**J2127A-05**

**S E R V I C E N O T E**

**AGILENT J2127A Transmission Test Set**

**Small cracks on the front and back castings.**

**Figure 1 Location of J2127A Tie Bars and Spacers**

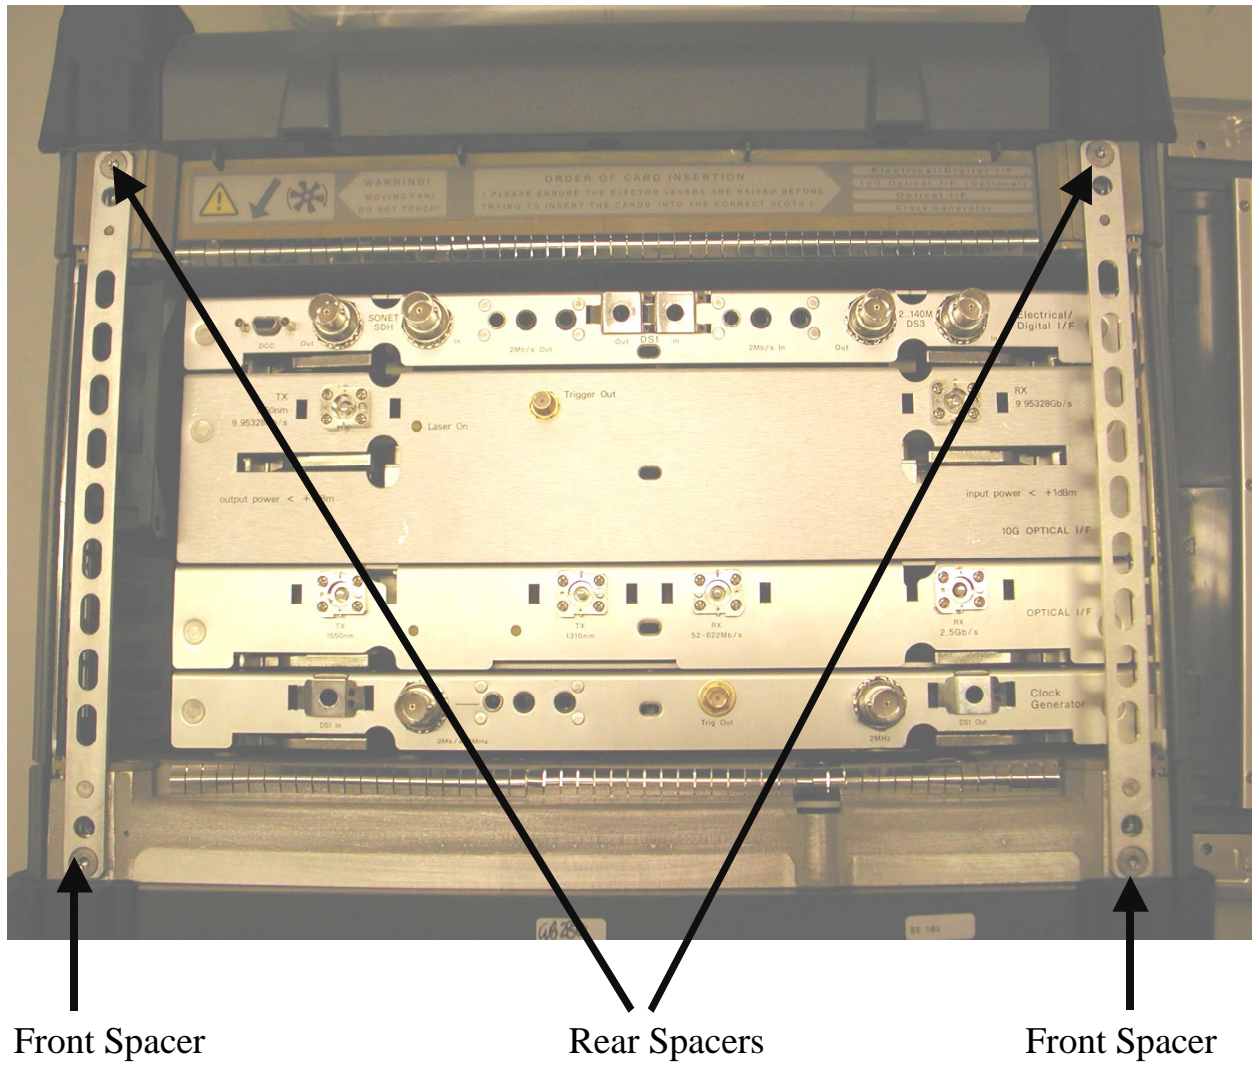
A failure may occur on the front or back castings due to some small cracks appearing around the screw holes at the corner of the castings. The cracks are caused if excess torque is used when screwing the tie bars to the castings. (The tie bars hold the front and back castings rigid.)

Spacers should be fitted between the tie bar and the castings.

1. Unscrew the torque #15 screws at each corner of the top panel.
2. Remove the top panel.
3. Locate the tie bars at either side of the instrument. Check the front and back of each tie bar to see if spacers have been fitted between the tie bars and the castings. See Figure 1.
4. If no, continue with step 6; if yes, go to step 8.
5. Unscrew the torque #15 countersink screws which fix the tie bars to the front and back castings.
6. Lift both tie bars and fit a spacer at the front (J1413-00052) and back (J1413-00053) of each casting, between the tie bar and the casting.
7. Replace the torque #15 countersink screws which fix each tie bar to the front and back castings.
8. Replace the top panel. Care must be taken to align the top panel with the connectors on the plug-in modules.
9. Replace the 4 x torque #15 screws to secure the top panel.
